DISCUSSION

Fig. 19 Predicted pressure ratio at near-stall points for tip clearance/tip chord ratios of zero, 0.25 percent, 0.75 percent, and clearance of 1.25 percent aft of 29 percent and 50 percent chord and forward of 50 chord

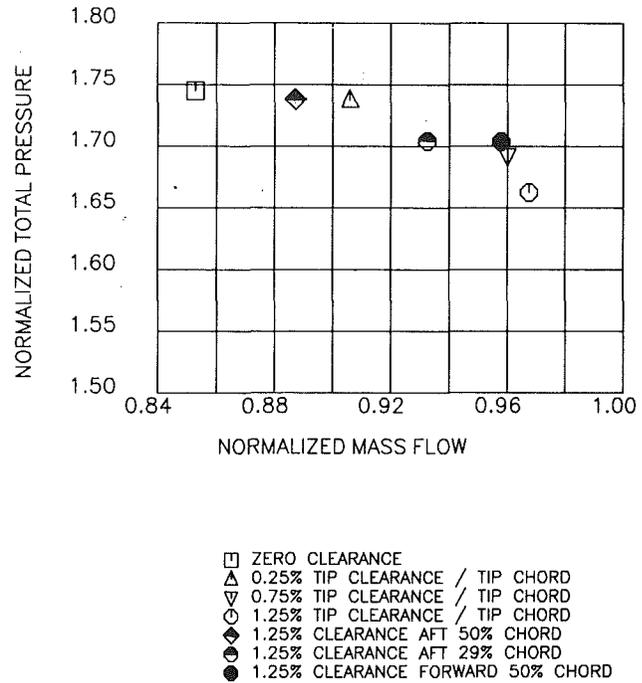
This is a very useful contribution to our understanding of the difficult problem of tip clearance flow. I think that our understanding could be further helped if the authors would complete the test cases given in Fig. 16 and show the effect of having clearance near the front of the blade but zero clearance near the rear.

Based on Professor Cumpsty's suggestion, we have executed a simulation in which the clearance from the leading edge to midchord was set at 1.25 percent of blade chord, while aft of midchord the clearance was set to zero. The predicted peak pressure ratio and corresponding mass flow are indicated by the solid octagon in the accompanying figure, along with the results previously presented in Fig. 16. By opening the clearance over the forward 50 percent of chord, the peak pressure and corresponding mass flow are nearly those for the same clearance over the entire blade chord. However, as previously shown, for clearance over the aft 50 percent of chord, zero clearance over the forward 50 percent chord, the peak pressure and corresponding mass flow lie closer to those for zero clearance.

The computations show that the clearance over the forward portion of a fan blade is far more important than that over the aft portion of a blade in establishing the peak pressure rise of a fan. Further, by reducing the clearance to zero over the forward portion of a fan blade, the interaction between the in-passage shock and the clearance vortex is reduced, leading to an increase in the operating range.
